In the Matter of:
The Application for Certification
for the Calico Solar Power Project
Licensing Case

Docket No. 08-AFC-13

PREPARED DIRECT TESTIMONY OF DAVID A. KRAUSS, Ph.D.
Senior Managing Scientist, Exponent

A.5 We were asked to review and have reviewed the Staff Assessment and Supplemental Staff Assessment, Part II, on Traffic and Safety, as it relates to glare and glint, the associated study referenced in Appendix A, and to render an opinion as to the adequacy of the study and conclusions contained therein.

Visual Search:
Find the upward tilted purple line

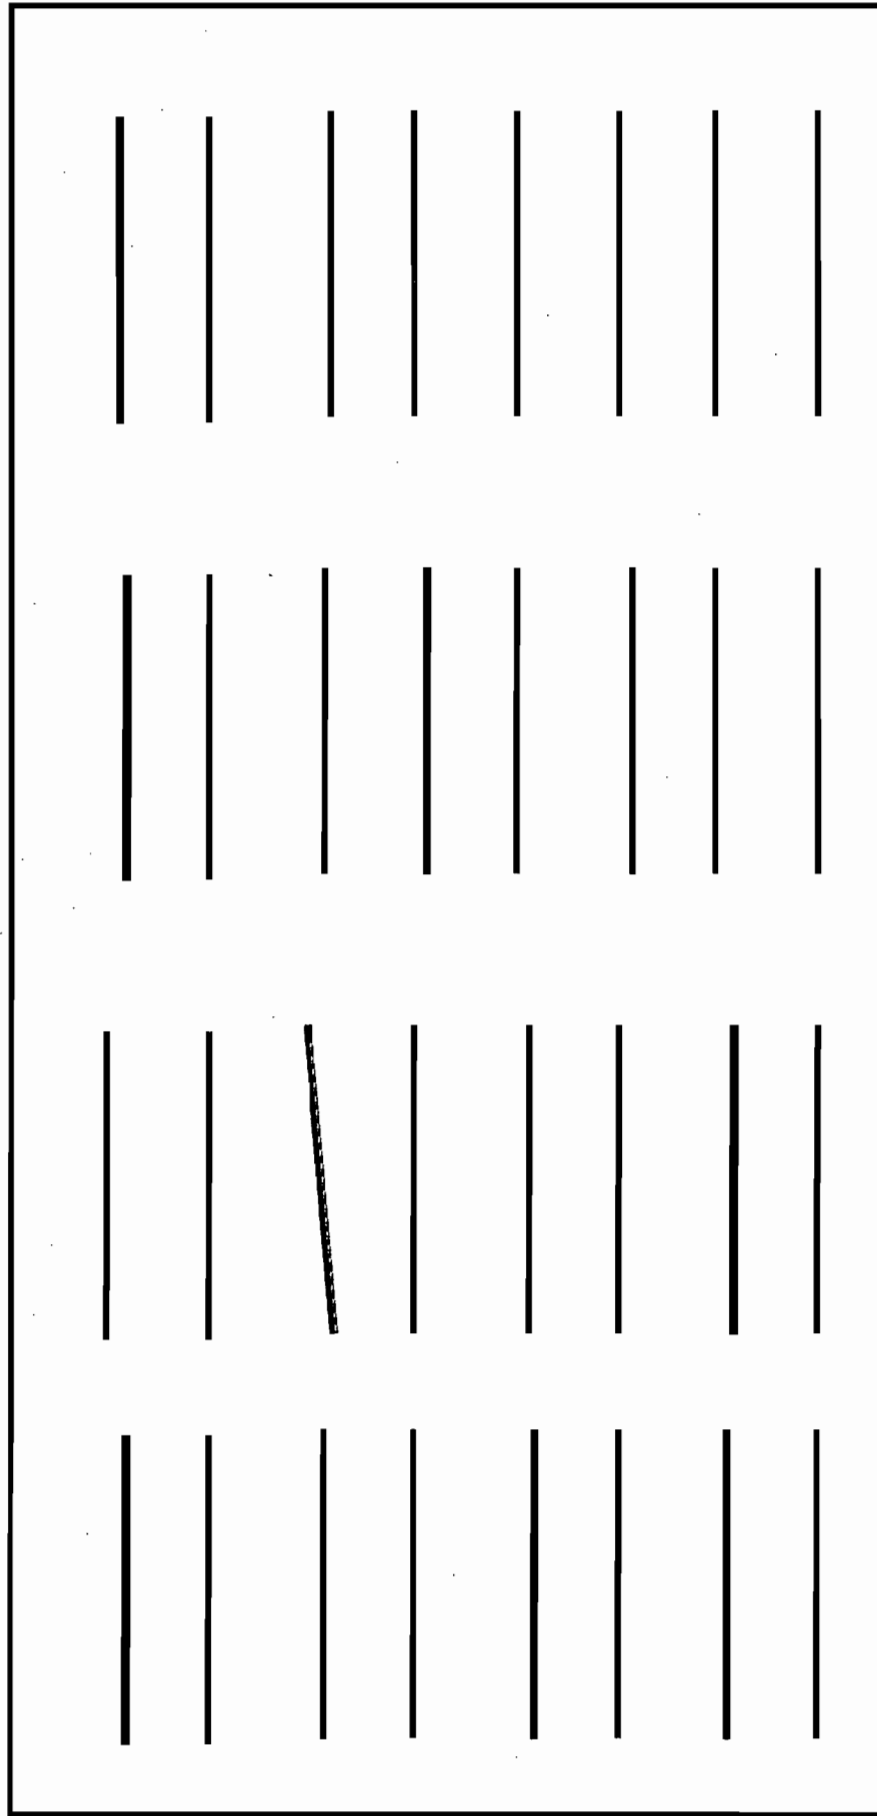
A.15 Exhibits 1-2 demonstrate an important concept in visual search – that is, that the background against which a target (in this case, the upward tilted line) is viewed

has a significant and measurable impact on the ease with which that target is located. Exhibit 3 illustrates the “phantom signal” phenomenon, in which direct external illumination can hinder a driver or operator’s ability to discern whether a signal light is illuminated. Finally, Exhibit 4 depicts a simple demonstration of the spatial summation of light.

“Phantom Signals”

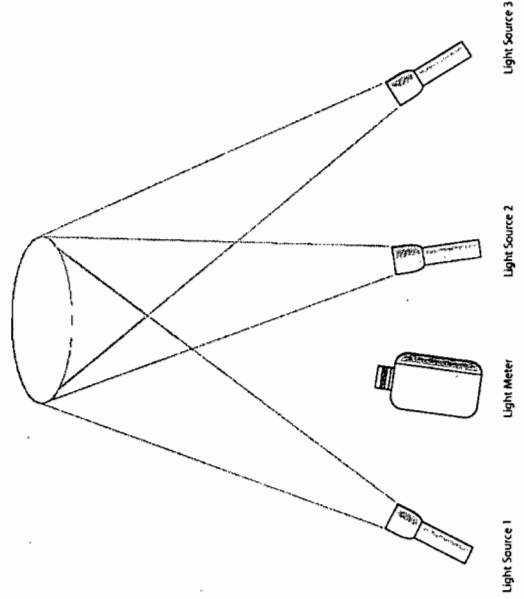
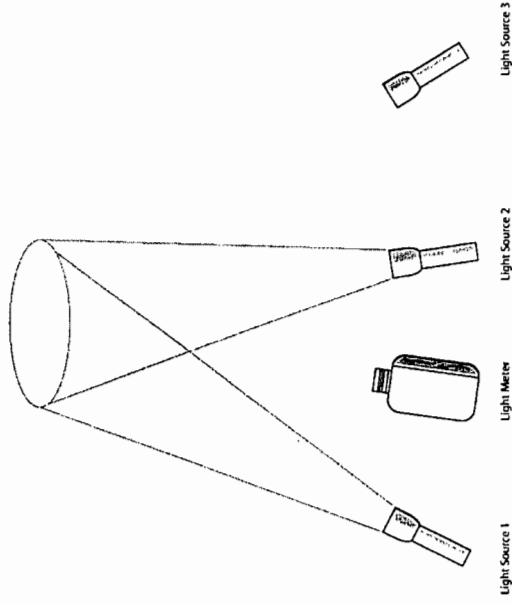
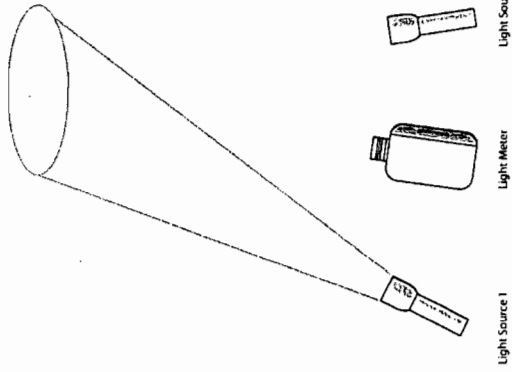
Excess of direct external illumination on a signal makes it difficult to discern which signal is illuminated.
